First Amendment to Zoning Development Agreement Snowbasin Resort

The following is a descriptive narrative prepared to outline the process and current state of proposed revisions to Sections 3 and 5.3 of the Zoning Development Agreement, dated January 11, 2011 ("Development Agreement"), and is intended to shed light upon the refinements necessary for the development and conceptual master plan for the Snowbasin Resort.

SNOWBASIN DENSITIES / TRANSFERABLE UNITS REQUIRED

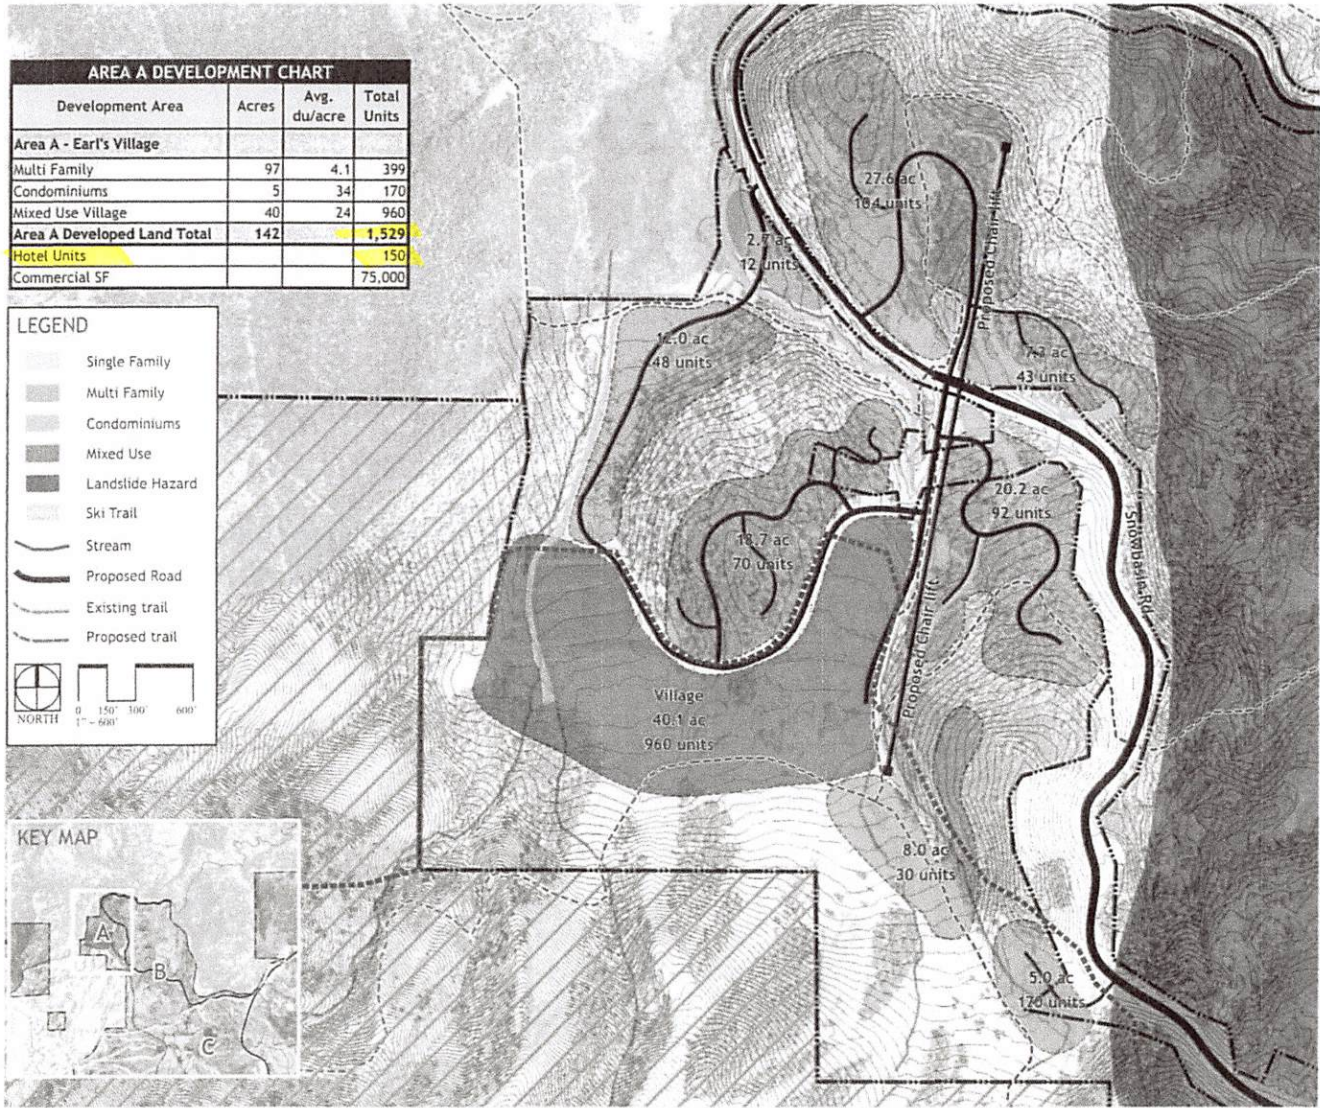
Additionally, Snowbasin is requesting a modification to section 5.3 of the 2011 Development Agreement in order to allow more flexibility regarding product type and to encourage hotel and commercial development which are anticipated to add activity and vitality to the resort. Some of the modifications are based on the approach taken in the previously approved Powder Mountain Development Agreement. Specifically, we propose that the limitation on commercial density including hotels in the ski areas (Areas A and B) be deleted. We believe it is in the interest of the resort and the county for these areas to be as vibrant as possible and that it is essential to remove these limitations. Limitations on commercial in non ski areas (F and G) remain unchanged.

The approach for counting density in the existing Development Agreement can be somewhat difficult to understand, particularly related to hotels. We propose a simplified approach and table based on the previously approved Powder Mountain Development Agreement, counting hotel density based on each hotel room counting as the equivalent of 1/3 of a single family dwelling unit. Our intention is not to request additional residential density, but to clarify how this density is counted. We also wish to encourage commercial, ski support and employee housing by not including these areas in density calculations in ski areas A and B.

The original and proposed density using the new simplified approach is calculated as follows based on Development Agreement Exhibit B page 27 table entitled “Snowbasin Densities / Transferable Units Required”:

- Add 150 room hotel / 3 = 50 units
Commercial – Area A – Hotel (not counted)
Commercial – Area A – Retail, etc. (not counted)

Add Commercial – Area G – Retail, etc. $140,000$ square feet / $5,000 = 28$ units

Total Area A density new approach: $1,529 + 50 = 1,579$ units

Total Area G density new approach: $297 + 28 = 325$ units

All Areas A, B, F and G combined total 2,428 units
